Re: Watson Cogeneration Steam and Electric Reliability Project
Application for Certification 09-AFC-1

REMAINDER OF RESPONSES TO CEC DATA REQUESTS #1-39 APPLICATION FOR CERTIFICATION 09-AFC-1

for Watson Cogeneration Steam and Electric Reliability Project

WATSON COGENERATION FACILITY
(PROJECT PLUS EXISTING FACILITY)
DRAINAGE AREAS AND ACREAGES
FIGURE B-1

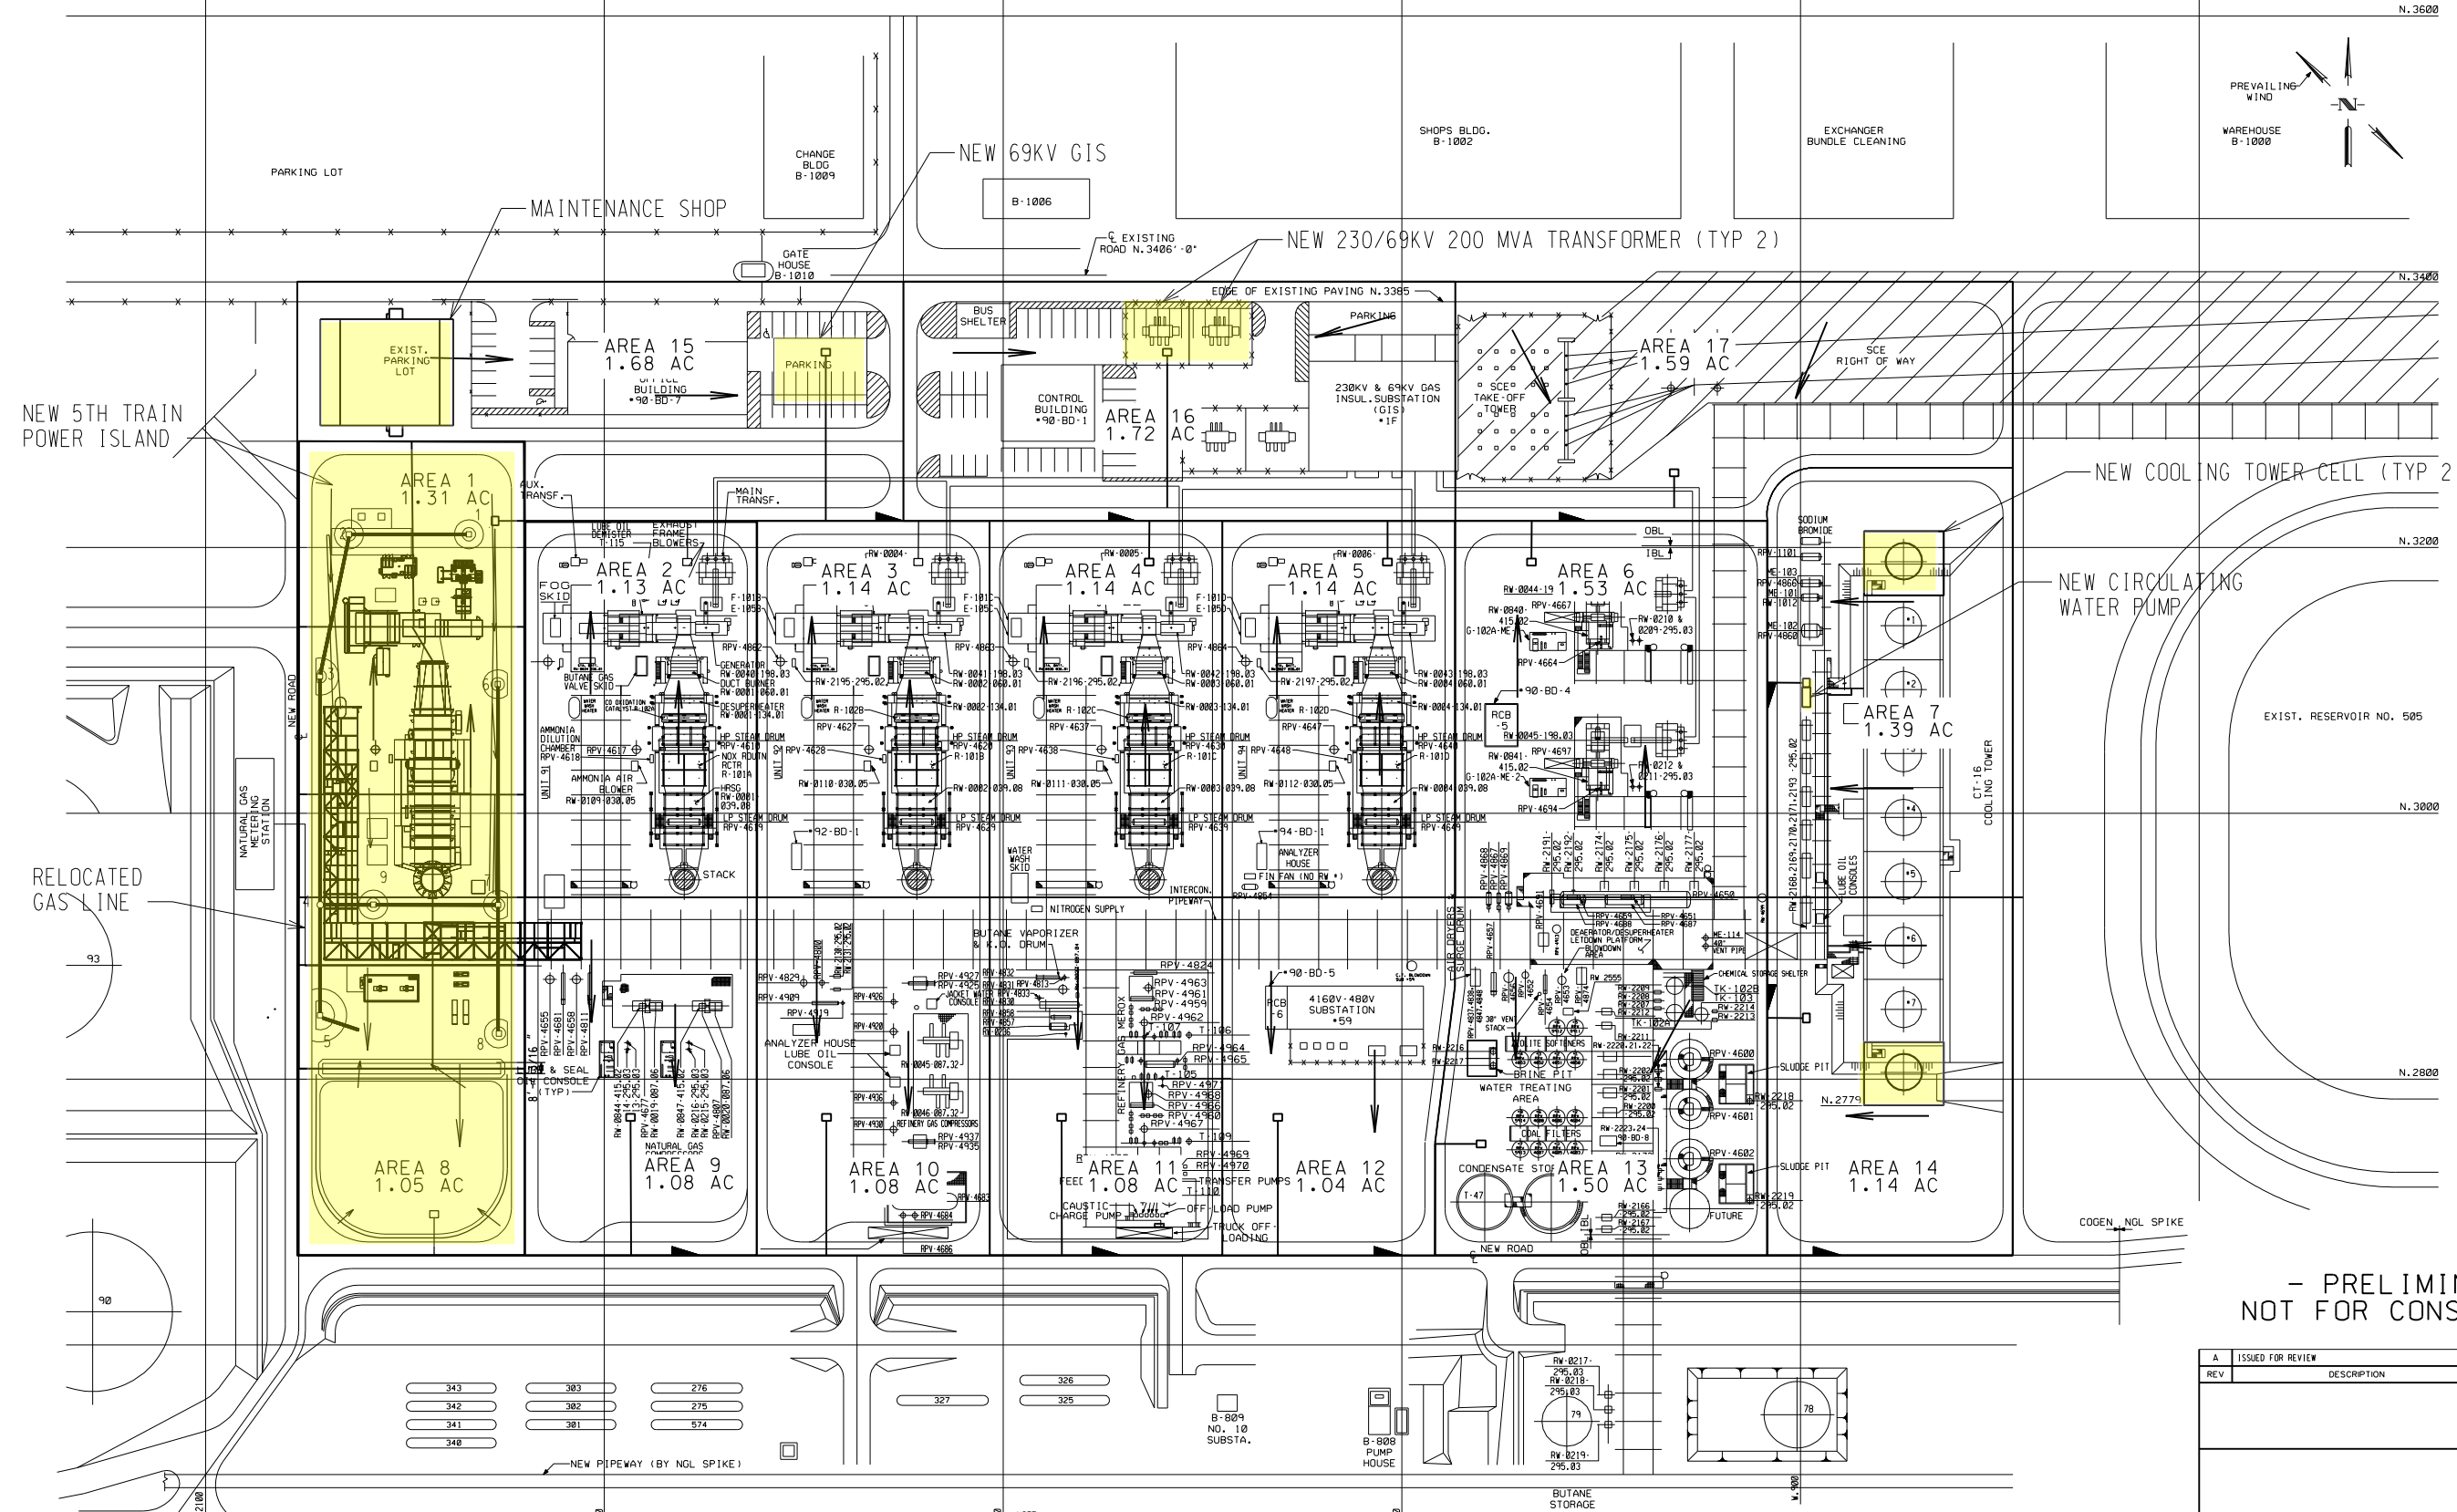
28. Please provide detailed runoff calculations estimating peak discharge for 10-year and 100-year rainfall events and runoff volumes for 10-year and 100-year, 24-hour rainfall events for areas within the Watson cogeneration plant (existing and with the proposed expansion).

Pre-development peak discharge for BP Watson Cogeneration facility is 66.8 cubic feet per second (cfs) and 104.1 cfs for the 10-year and 100-year events, respectively. These values correspond to 21.72 acres which were subdivided into drainage areas according to Figure B-1. The runoff volume for pre-development is 310,900 cubic feet and 490,100 cubic feet for the 10-year and 100-year events, respectively.

Post-development peak discharge is expected to slightly increase to 68.9 cfs and 106.0 cfs for the 10-year and 100-year events, respectively. This is due to 2.36 acres having a higher runoff coefficient due to being paved instead of graveled. Figure B-1 shows areas 1 and 8 as the addition of the fifth power train. The runoff volumes are also expected to increase to 322,700 cubic feet and 503,200 cubic feet for the 10-year and 100-year events, respectively.

Calculations from Hydraflow Software are attached with Figure B-1 showing the sub-areas and size.

Fogging Frequency Estimate for
 Carson Cogen
 Lillie-Hoffman Ext Cell

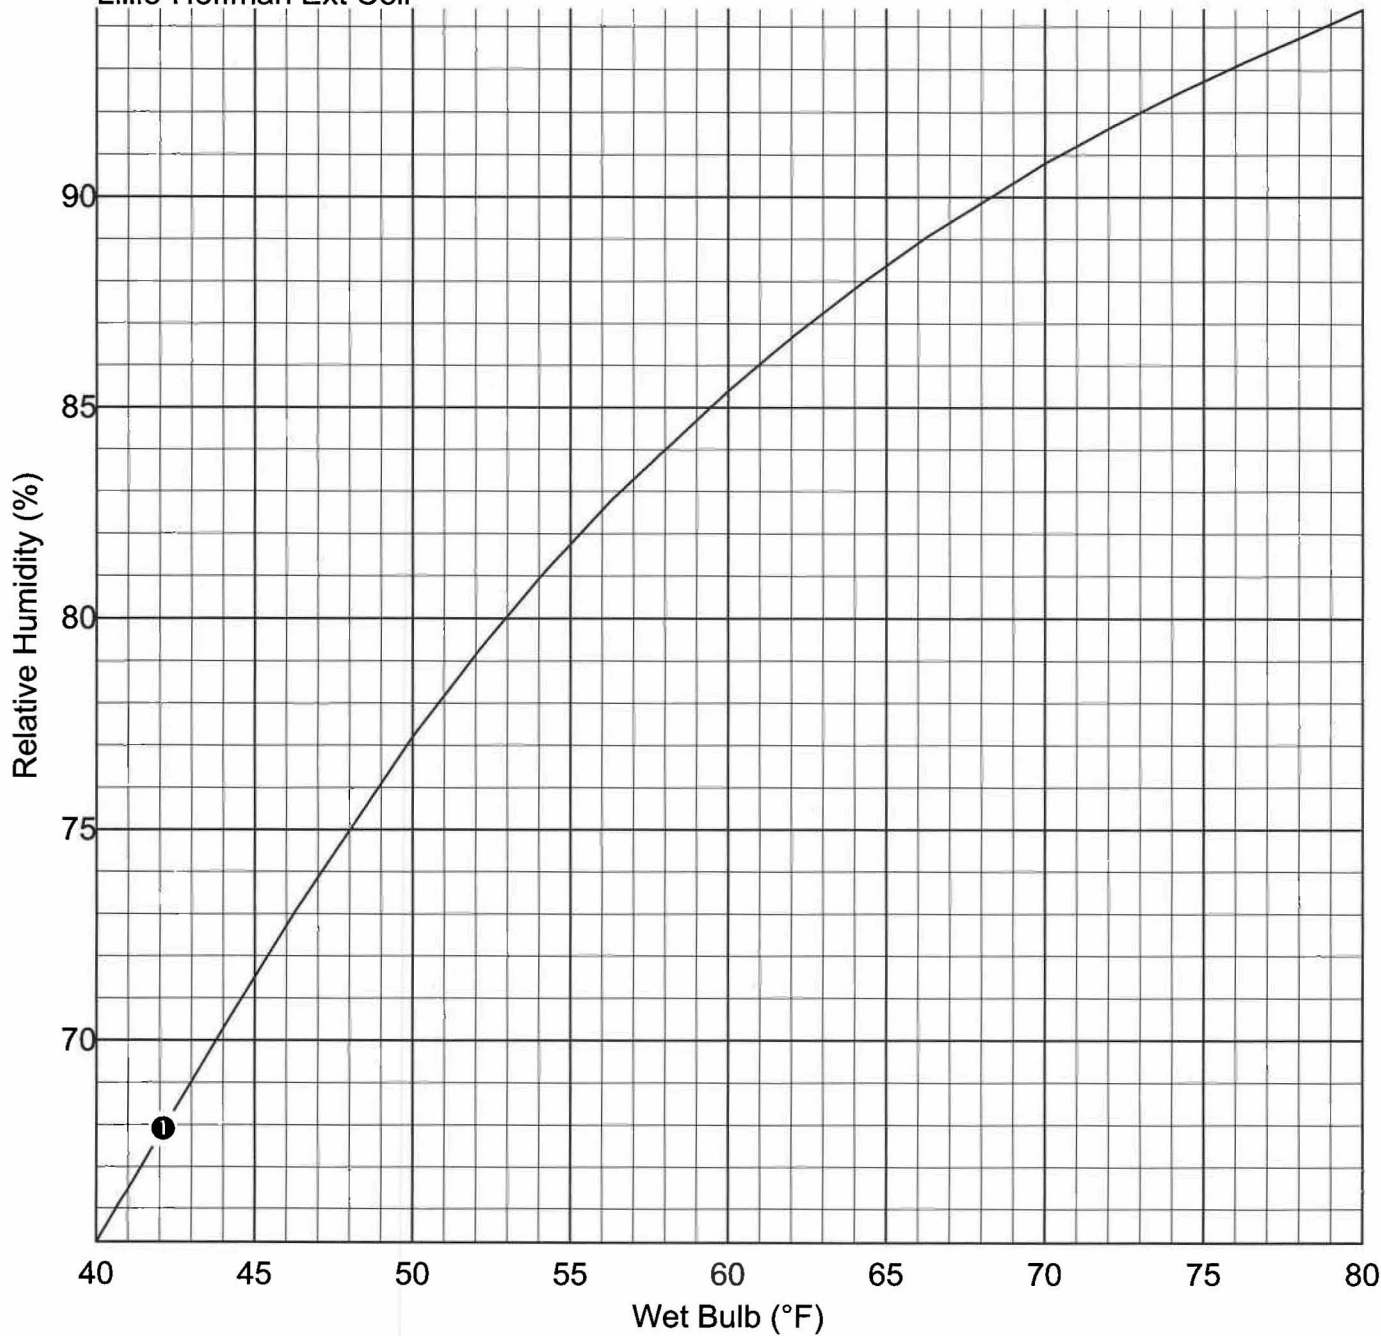
34. Please provide a fogging frequency curve from the cooling tower vendor, if available, for the existing cooling tower, and if designed/operated differently, for the two new cells being added to the cooling tower.
